Proposed Extension
At:
2 Oldfield Crescent
Southwick
Sussex
BN42 4FZ

Plans & Elevations As Proposed
OPTION 3

Drg. No.	Rev'n
05	A

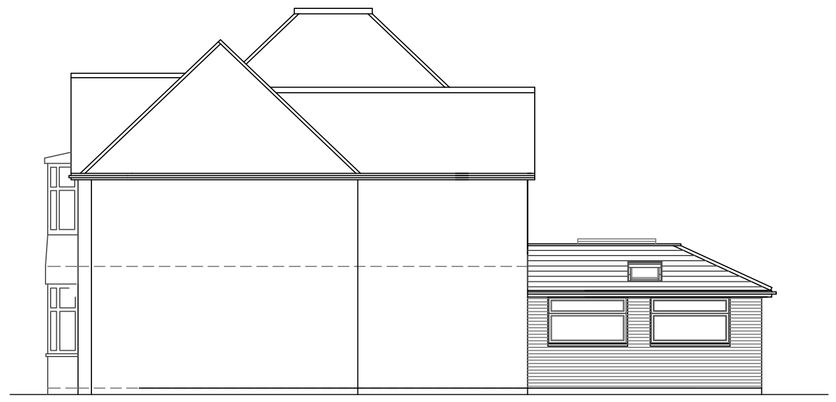
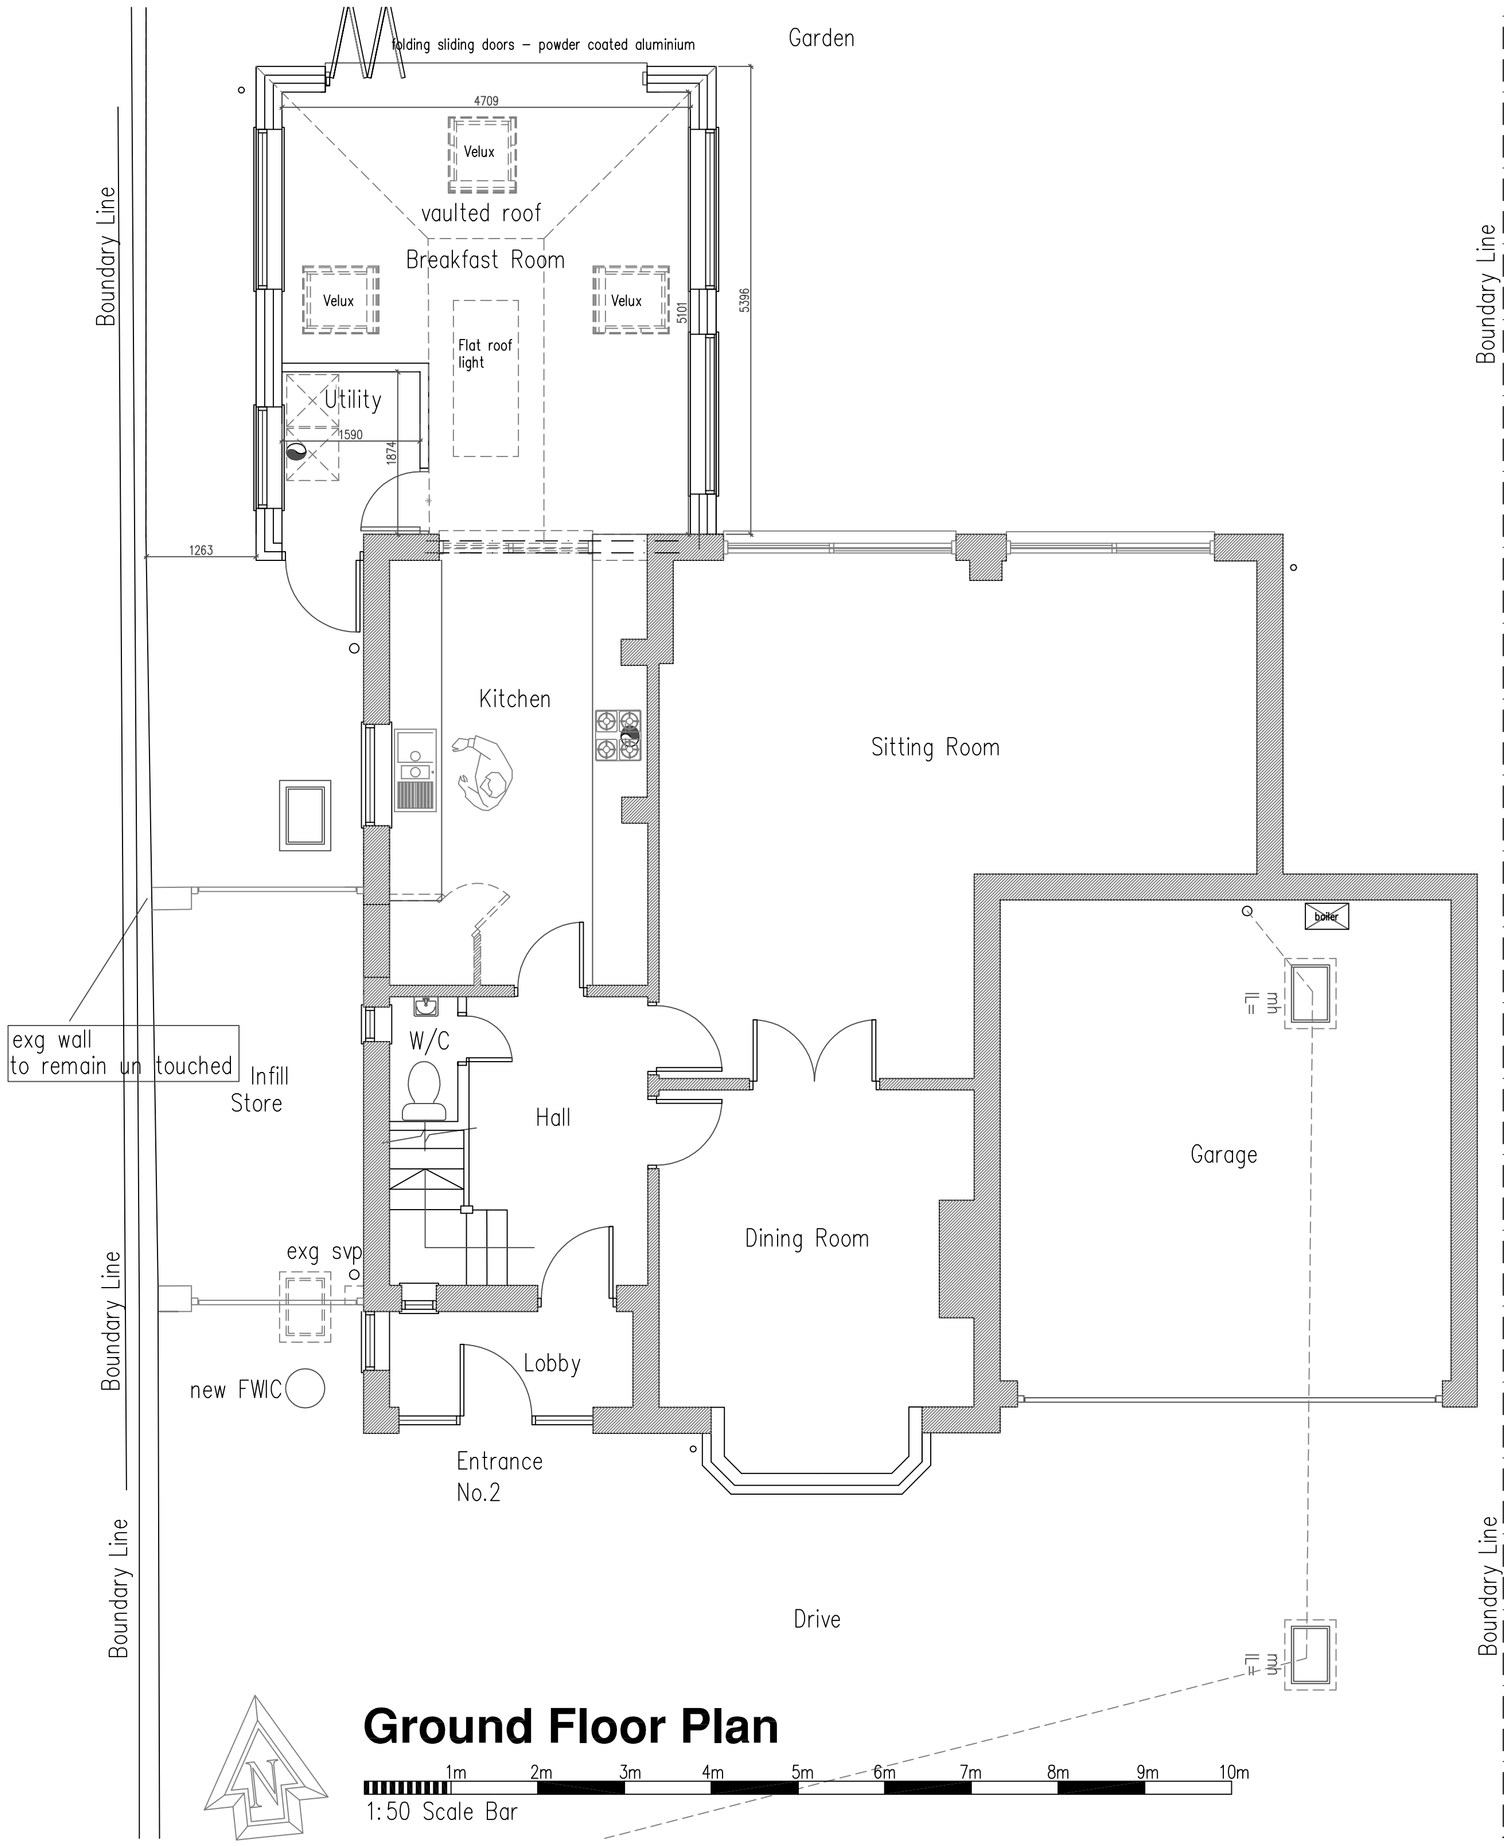
The existing wall will be used for the side boundary of the store, a plastic roof is proposed with the side wall not being built up but a plastic sheet being used.

On the basis of this clarification the store will not be P.D and will require planning permission due to the materials to be used (i.e. plastic and therefore will not match existing. Therefore it must form part of the application.

Also we need a side elevation of the store showing the proposed changes. After looking at the site photos again I have concerns that the plastic side panel would be visible in the street scene and would be detrimental to the character and visual amenity of the area. As this needs consent and forms part of the application I would request that the existing wall is build up in bricks to match existing and that this is shown on the plans as well as the details of the materials for the proposed store roof given.

We need to know if the existing boundary wall will be built up to form the side wall as the floor plan suggests or if the boundary wall will remain unchanged and the new store wall and structure will be built within the boundary wall as the front elevation suggests – both are showing conflicting information.

Please find attached amended plans and elevations which show a dummy pitch roof to the covered store which will have tiles to match existing house which would not be detrimental to the character and visual amenity of the area. There will be a flat section of roof where Rainwater will run off to the rear and not the side. (no projecting guttering etc over boundary). The existing boundary wall has been built solely on no.2 land

Is this ok, I have tried to show that boundary wall will not be touch or built over.

Hannah
Guttering will not project of existing boundary wall
Do we need planning for this store covered roof anyway?
If not then remove it from application
Regards
Ben
Sorry I cannot call as I can't use phone in office at work
From Monday to Wednesday
I work from home Thursday and Friday
